SERVICE BULLETIN n°990201

ATA SYSTEM : 56
EFFECTIVITY : CAP10B
TITLE : Canopy locking hook

Figure 1 : Canopy locking hook

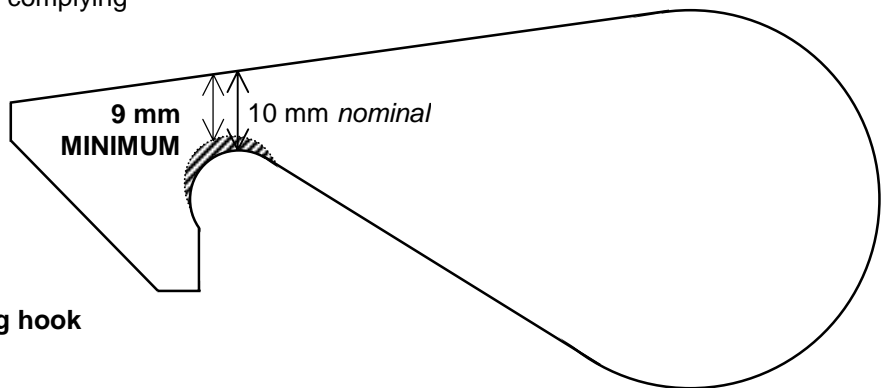
The locking hook failure appears after an excessive filing of the tumbler. It is sometimes necessary to modify this part in order to adjust the installation of a new windshield.
The material quantity left on the locking hook must be at least of 9 mm (0.35 in) minimum.
This measure is accompanied with an inspection of the part.

- A. Check the hook (located #49 on the 15B planch of the Parts catalogue)
- B. The tumbler depth must not be so that material quantity left is **9 mm (0.35 in) minimum**
- C. Replace the part if non complying

- A. Check visually the canopy locking hook each **50 hours inspection**
